Council Bill: B 372-13

RE: Statement of Intent / Application for Permanent Rezoning and Planned Unit Development Plan / The Avenue at Columbia (the "Development") / Park7 Group (the "Applicant")

Re: Park 7 Group rezoning and PUD plan approval (Case # 13-204)(Supplemental Information)

PRELIMINARY PLAT & PUD PLAN THE AVENUE AT COLUMBIA

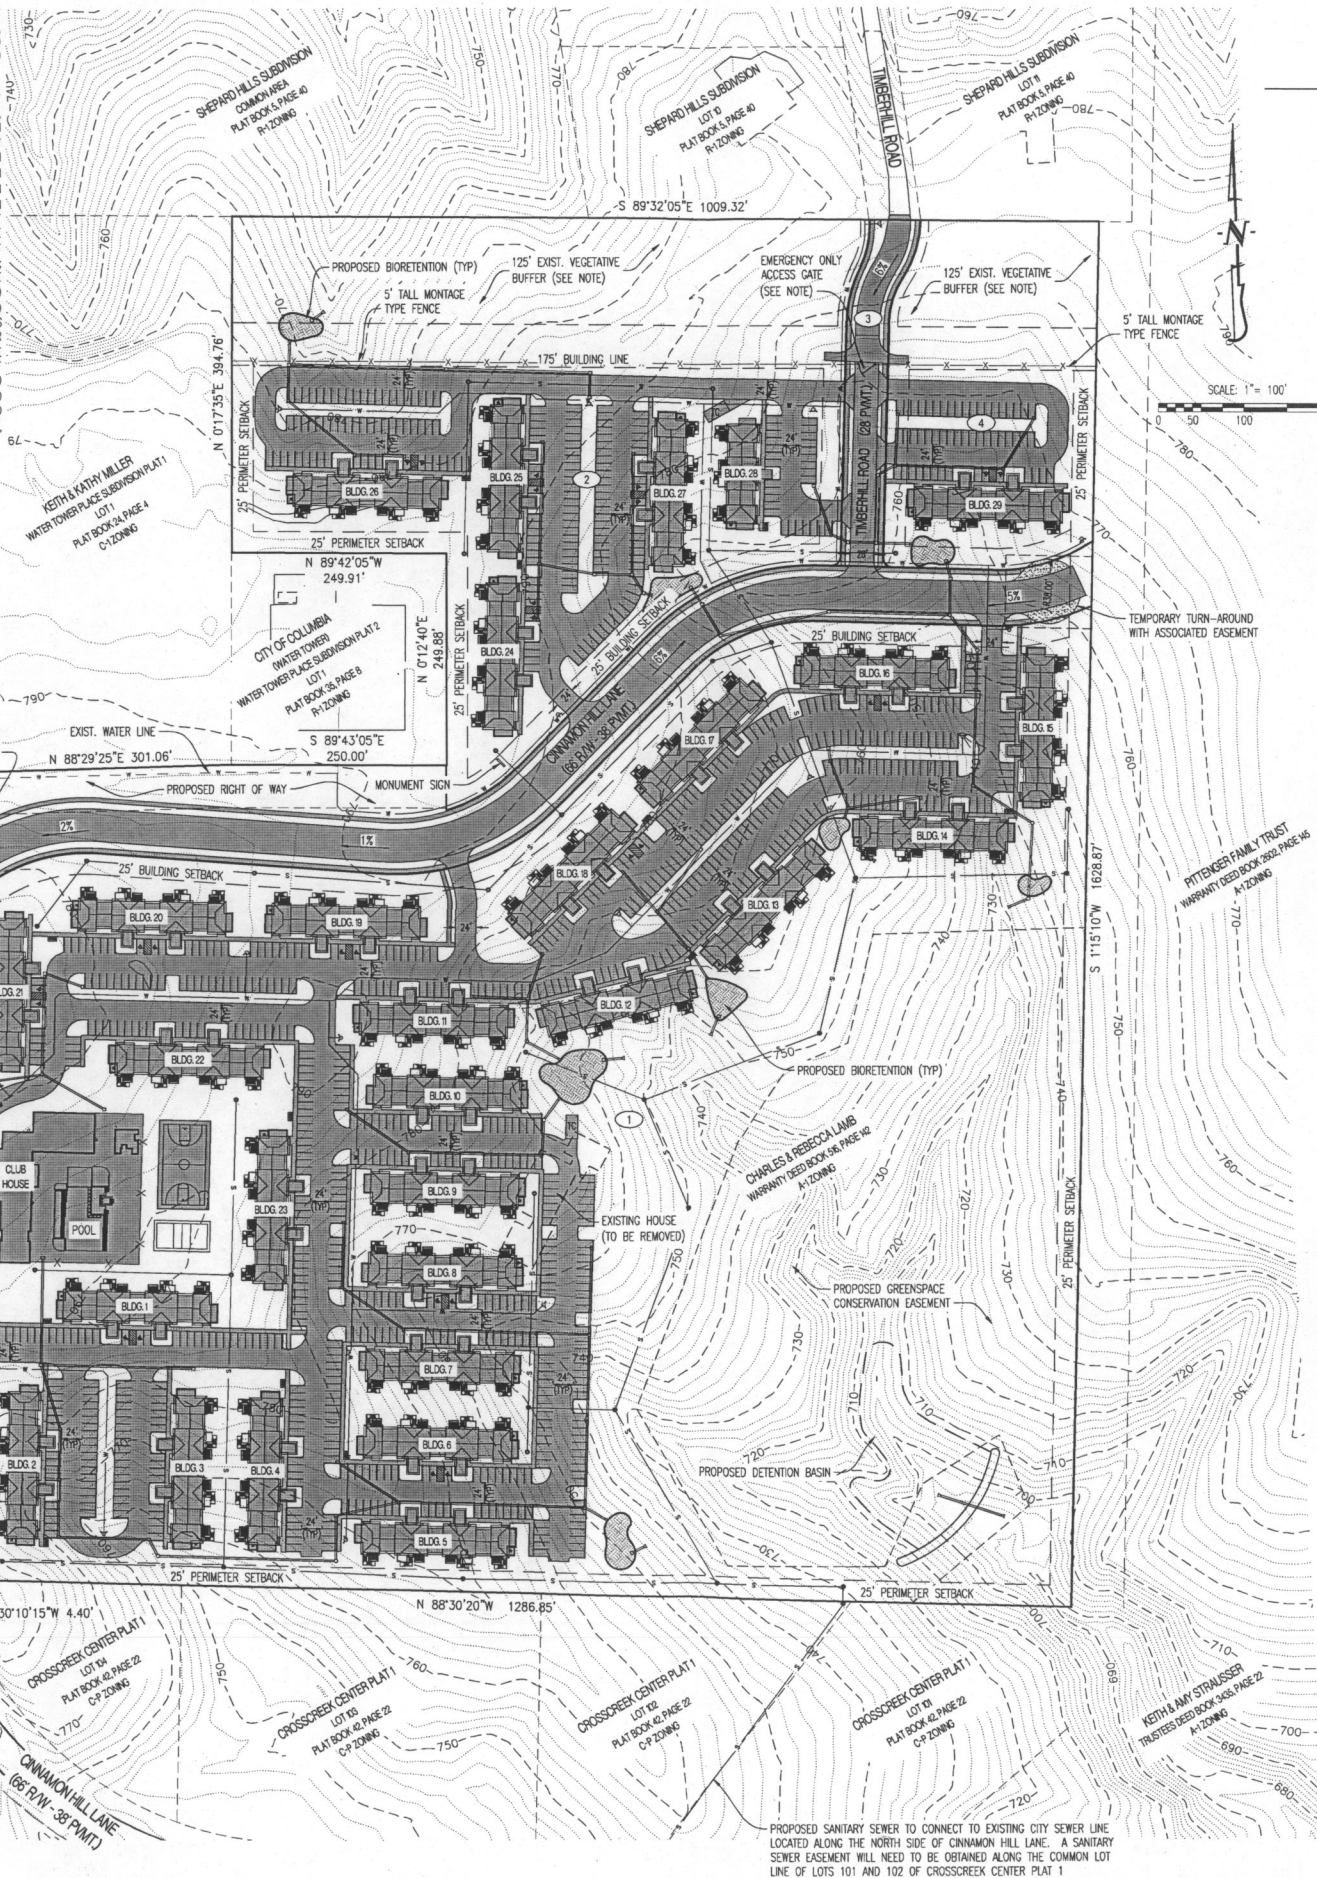
This proposal was tabled by Council during its January 21 meeting following the applicant's presentation of a revised Statement of Intent (SOI) which had not been reviewed by staff prior to the meeting. The changes in the SOI also resulted in the necessity to submit a revised PUD development plan.

1. The proposed increase in building setbacks (100 feet to 175 feet) along the northern property line has resulted in 4 buildings being relocated to the south central portion of the site. The area previously proposed for development is now shown as a combination of conservation easement and tree preservation. This additional area off-sets changes to the previously identified conservation easement area in the southeast corner of the site.

2. The additional 175 foot setback area is divided into two types of zones. The first 125 feet south of the northern property line is a "no build" area - all existing vegetation is to be preserved and the only improvement will be for the extension of Timberhill Road. The next 50 feet will have no building construction within it; however, may be graded. The development plan shows no improvements and based upon the SOI none would be permitted within this area since none have been shown.

3. The height of the proposed structures has been reduced to 37 feet as was recommended by the Planning and Zoning Commission and shown on the original development plan and included in the original SOI.

4. The total area allocated to climax forest preservation has been increased by 3% to a total of 28%. The amount to be preserved will remain at 25% as is required by ordinance. The location of proposed conservation easements; however, provide greater benefits to the surrounding neighborhood to the north.

5. The "montage" style fence has been extended along the entire northern property line at point 175 feet south of the northern property line. Installation of this fence addresses a Planning Commission condition of development approval.

6. The development plan shows the extension of Timberhill Drive with an emergency turnaround and gate as requested by adjacent property owners and supported by staff. The extension of this roadway and its full improvement as a residential street is necessary to ensure compliance with Section 25-54.1 of the Subdivision Regulations relating to multiple points of ingress/egress to PUD developments containing over 200 units. Allowing the roadway to remain closed to through traffic; however, operational for emergency purposes is consistent with previously approved developments of similar character.

A notation on the plan stipulates the conditions upon which the extension of Timberhill Drive would be opened. Opening of Timberhill Drive is conditioned upon the extension of Cinnamon Hill Lane to Route WW. The City; however, reserves the right to open the gate in times of emergency as it determines necessary.

A copy of the revised SOI, dated February 3, 2014, and updated site plans, revised January 2014, are attached.

CONCEPTUAL LANDSCAPING FOR THE AVENUE AT COLUMBIA

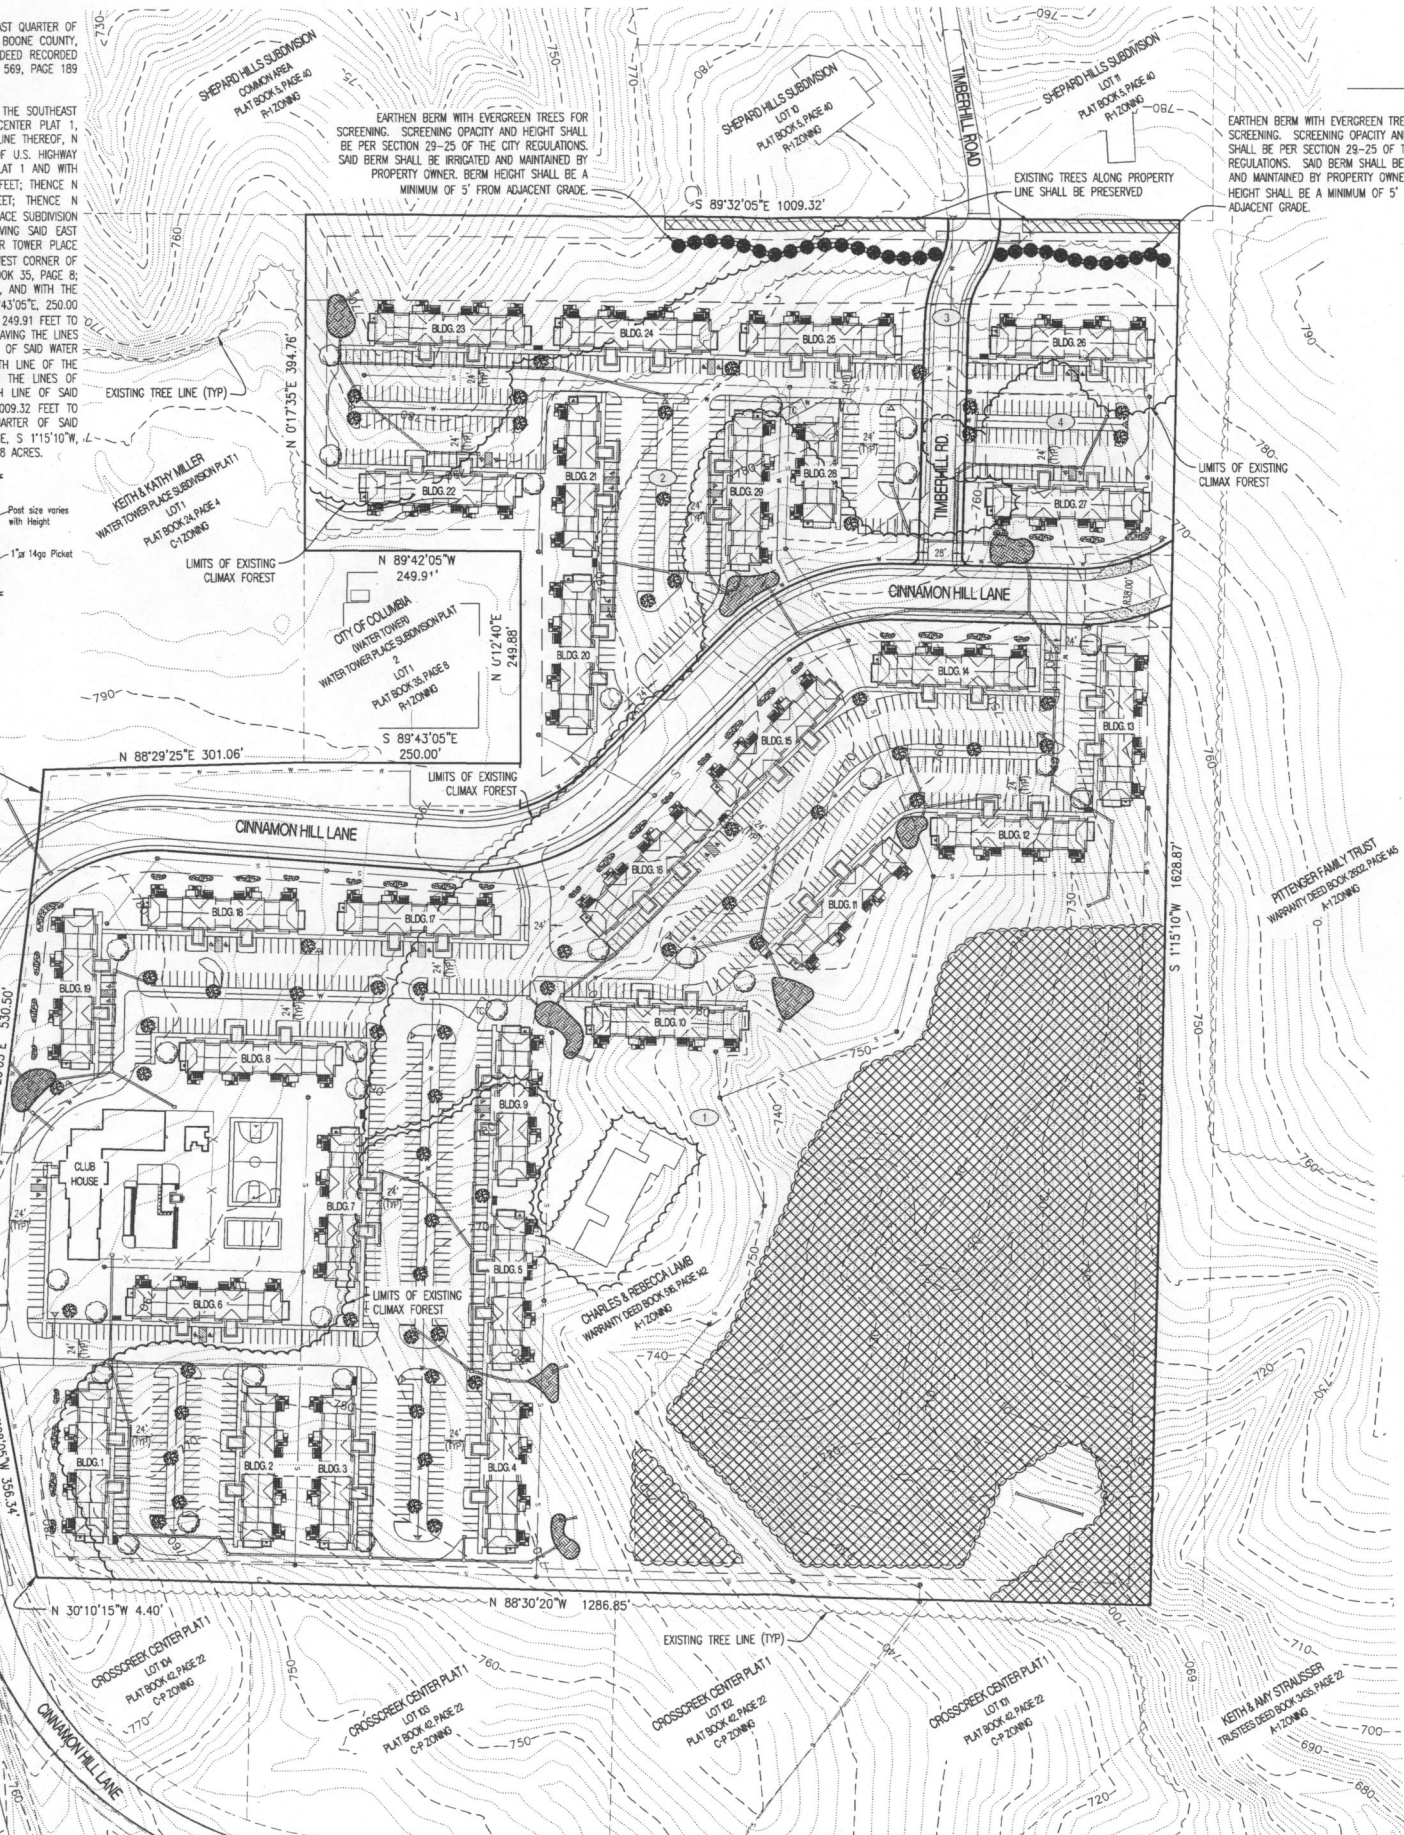
- Request approval of PUD zoning and Plan subject to the following conditions:
 - A note will be added to the plan requiring Park7 to **maintain and replace trees and vegetation** preserved along north boundary
 - The plan shall be modified to show a **berm of 5 feet in height** and containing evergreen plant material
 - A note will be added to the plan requiring the **berm to be irrigated and maintained** by Park7

- Conditions continued:
 - The plan will be modified to show the **building line no closer than 100 feet** from the north boundary
 - The Statement of Intent will include obligations of Park7 to **extend the left turn pocket** by 300 feet and to include a dedicated **east bound left turn signal** upon MoDOT approval (at Audubon and Stadium)
 - The Statement of Intent will **require private covenants** stating Park7's obligations which are enforceable by adjacent property owners/association
